Docket Item # 2
BAR CASE # 2016-00059 & 000060

BAR Meeting
April 6, 2016

ISSUE: Partial demolition and alteration

LOCATION: 426 North Union Street

JELD-WEN WINDOWS & DOORS Window Division - Bend	CUSTOMER NAME: STOCK		BAR ALIGNMENT? YES	SCHED. DATE:	LINE #:	ORDER #:
	CUSTOMER P.O.:	02/26/16	REVISED DWG:		BY: KAK	CHK'D BY:
						DWG #: F2651116

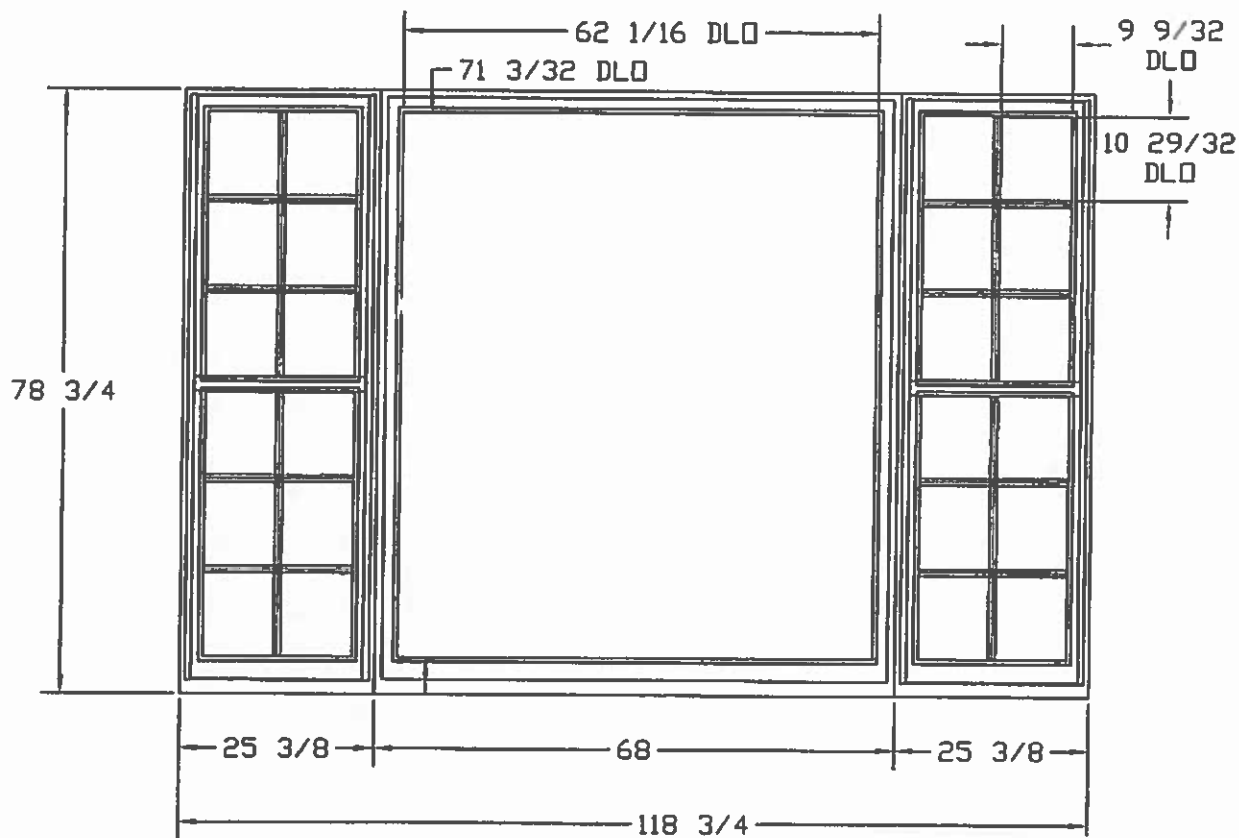
In this particular instance, the request is for a single light picture window with small double hung, multi-pane windows on either side. Because this mid-20th century Ranch Style window type is foreign to the Federal style, and would be inappropriate on most buildings in the historic district, it seems out of place on this facade. Staff does not oppose the request to increase the window area but believes the alteration should be in keeping with the architectural details of the original style of the building. The BAR's *Design Guidelines* state: "It is the strong preference of the Boards that architectural elements of particular styles not be mixed and matched on the same addition." (Residential Additions, p. 2) In addition, while this window seems like a very minor feature, the *Guidelines* caution that "When considered individually, many of these items may seem relatively minor in nature; however, the cumulative effect of inappropriate small changes to buildings will erode the overall historic and architectural cohesiveness that makes the districts significant." (Building Alterations Introduction, p.1)

However, the range of elements used in the closely related Colonial Revival Style (1880-1955²) is broader than the original Federal Style and includes the use of paired and triple ganged, double hung, multi-pane windows. Staff, therefore, recommends that the masonry between the two existing windows on the second floor be removed and a third window of equal size and design be inserted in between, with mullions filling in between the three equally spaced windows. The triple window should be set in the same plane as the other windows and should not have shutters. The triple window arrangement should be comprised of multi-pane windows to coordinate with the other windows on this elevation.

3 PROPOSED FRONT ELEVATION
A1 SCALE: 3/16" = 1'-0"

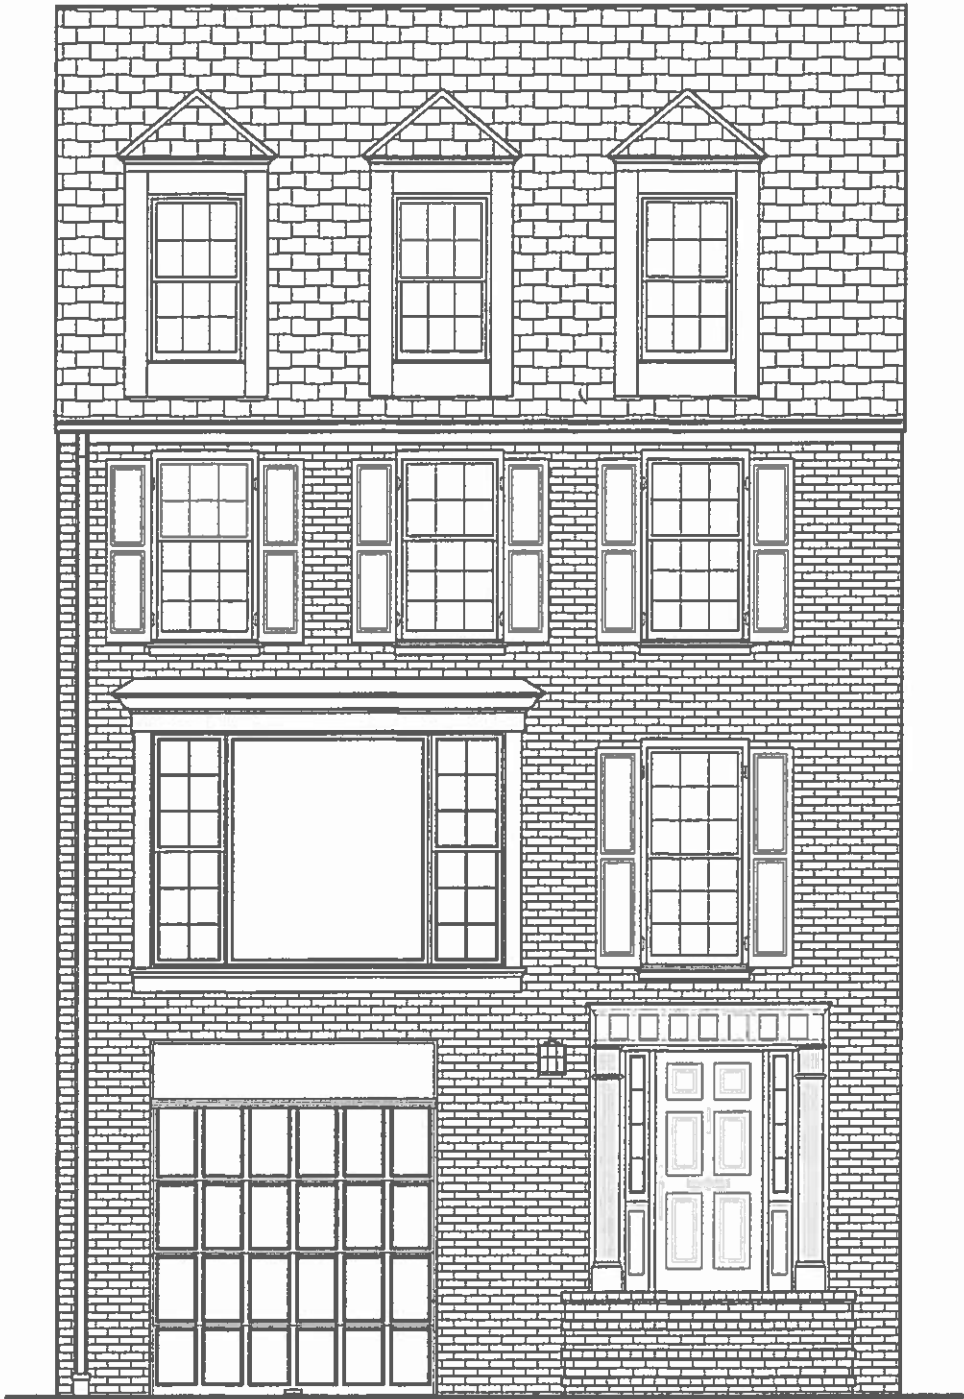
The applicant is requesting removal of a portion of the brick wall and two single windows at the second floor of the front façade in order to install a picture window. The new picture window is comprised of a large single-light fixed window flanked by six-over-six double-hung windows. The window is not a bay window, as it does not project from the face of the masonry wall, though the new window will be framed by a large head and jamb trim applied on top of the brick.

The proposed picture window alteration is both taller and wider than the existing windows and is surrounded by trim not found anywhere else on this facade. In addition, the existing garage door is not centered below the proposed new opening and this compounds the unsettled appearance of the facade. The applicant considered adding muntins to the larger, fixed center glass panel to relate to the rest of the windows on the façade but this seemed extremely awkward.

That the masonry between the two existing windows on the second floor be removed and a third window of equal size and design be inserted in between, with mullions filling in between the three equally spaced windows.
